ETE Sanitation And Landfill
Town Of Gainesville, New York

Final Remedial Investigation Report

NYSDEC Site #9-61-005
Work Assignment #D002925-24

Subject: ETE Sanitation and Landfill
Remedial Investigation Report Comments and
Additional Surface Water / Sediment Sampling

Figure 3-2
Site Property And Adjacent Lots
ETE Sanitation And Landfill Remedial Investigation

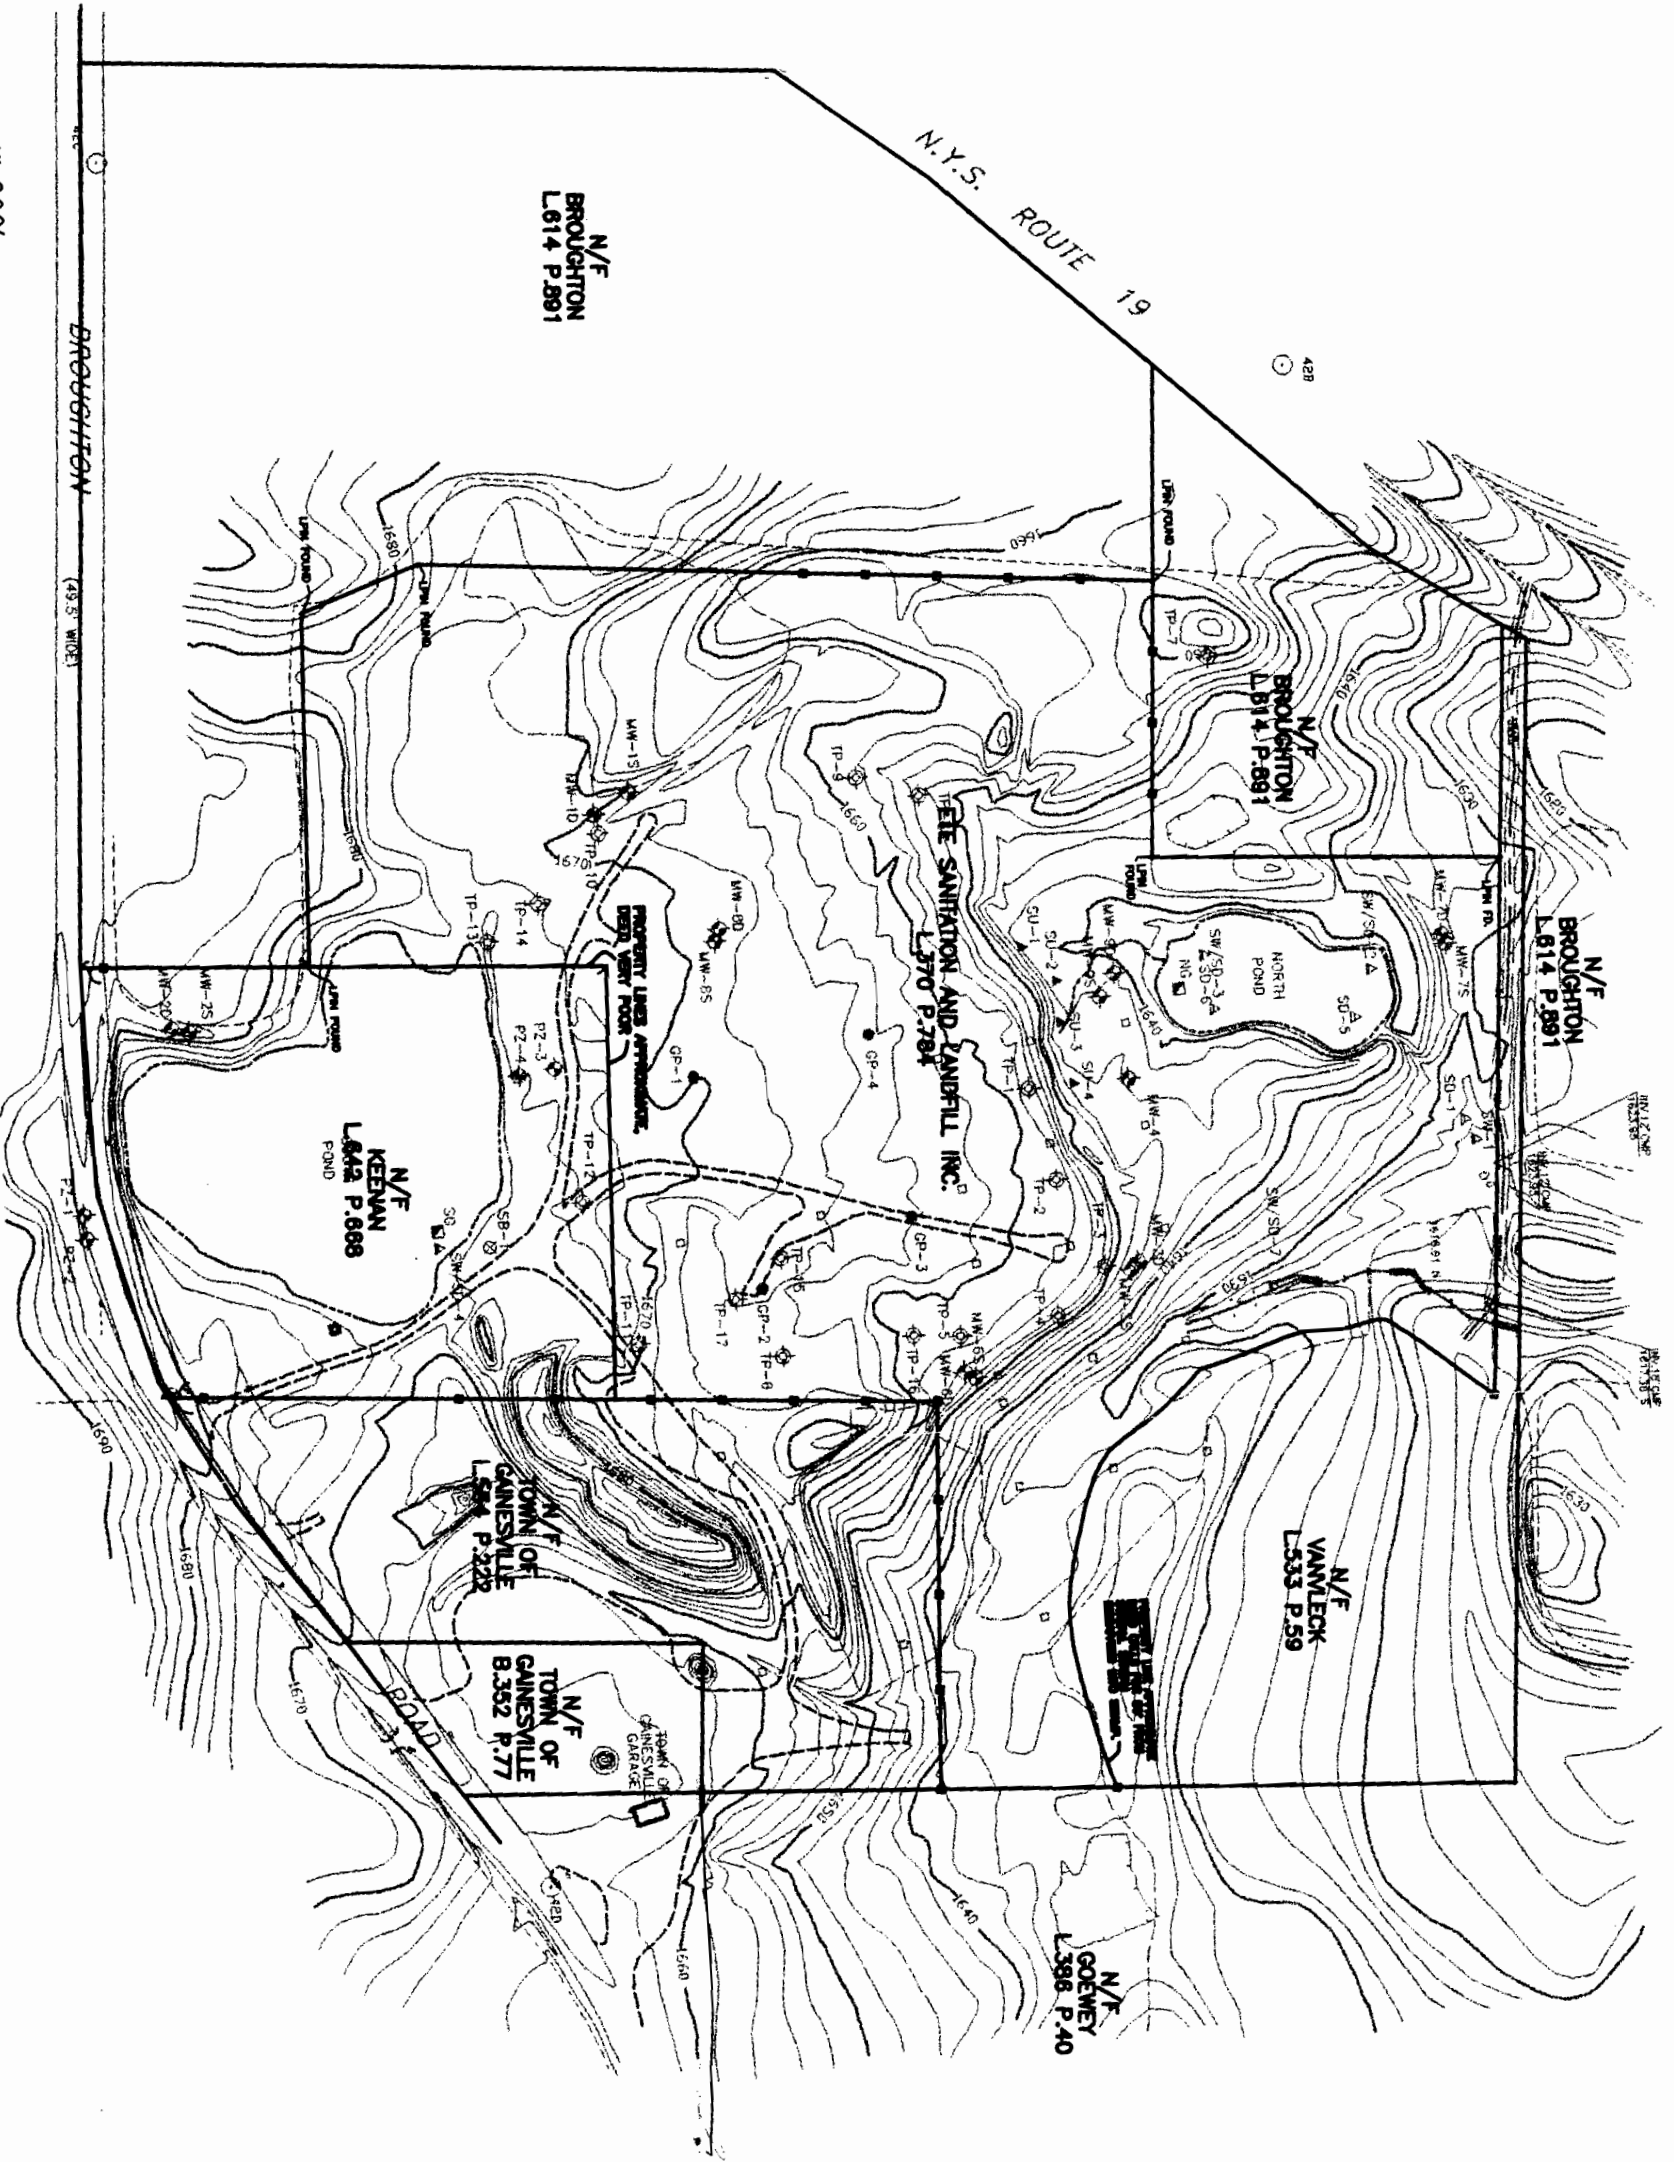
Comment 14: The entrance to N/F Keenan's property is shown to be from the Town of Gainesville property. Is this correct?

Response: Based upon the survey completed by our subcontractor, YEC Inc., figure 3-2 accurately shows property boundaries for lots found adjacent to the landfill.
